## COMMENT RESPONSE DOCUMENT

EASA PAD No. 25-080

[Published on 28 May 2025 and officially closed for comments on 25 June 2025]

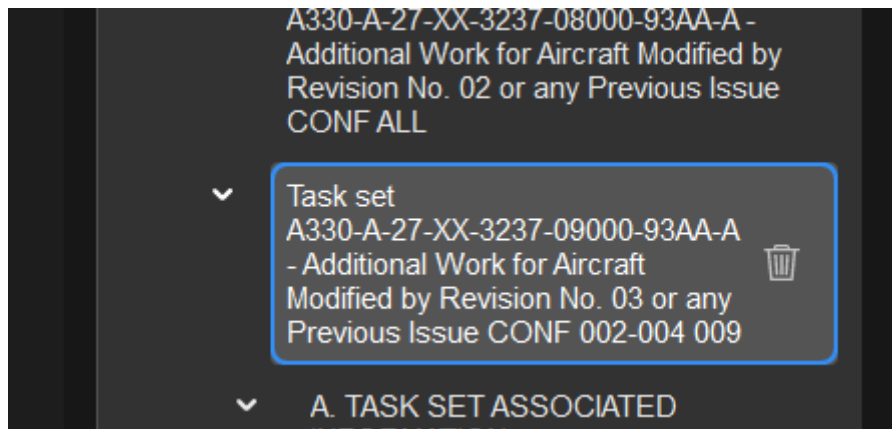
SB 27-3237 Rev 04 gives additional work (inspection) if SB 27-3237 Rev 03 is embodied (SB Rev1 or Rev 2 + additional work).

The AD does not give any instruction about requirements if SB 27-3237 Rev 03 is embodied.

Could you clarify the instructions if SB 27-3237 Rev 03 is embodied?

**Comment agreed. See EASA answer to comment #2**
